SIB 17 01 26

DELIVERY STOP: CHECK AND IF NECESSARY, REPLACE THE CHARGE AIR COOLER VENT LINE

2026-07-10

This Service Information Bulletin (Revision 1) replaces SI B17 01 26 **dated May 2026**.

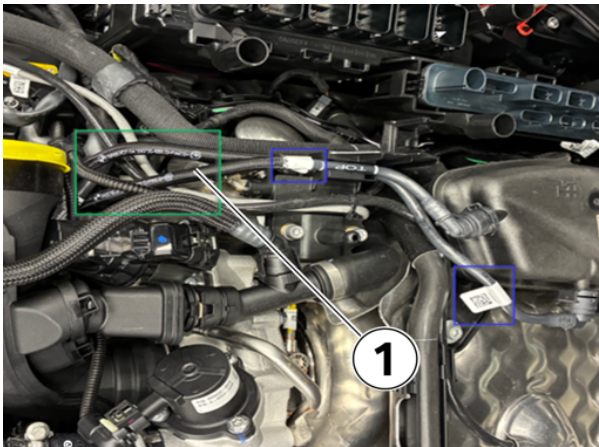
Inspect the index number on the vent lines.

- **If the Index number is less than AI-04, replace that vent line**

- If the index number is AI-04, or higher, no further repair is necessary

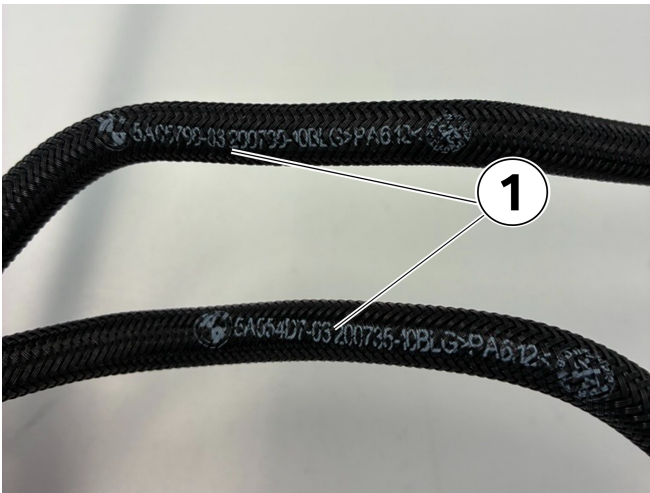
2. Check the Index number on hose PN 5A054D7 and 5A05798 (1), located within the marked boxes.

3. The index number is the two digits after the PN (1). NOTE: Example shows index AI-03

4. Are the lines indexed AI-04 or higher? Yes, go to step 6. Index lower than AI-04? Go to Step 5.

5. Replace the affected line/s.

NOTE: There is the possibility that only one of the two vent lines has an index lower than 04.

Follow repair instructions **RA 17 12 626 Low-temperature expansion tank - charge air cooler coolant hose, left** and/or **17 12 627 Low-temperature expansion tank - charge air cooler coolant hose, right**.

NOTE: It is not necessary to drain the entire low temperature cooling system during this repair (contrary to the repair instructions).
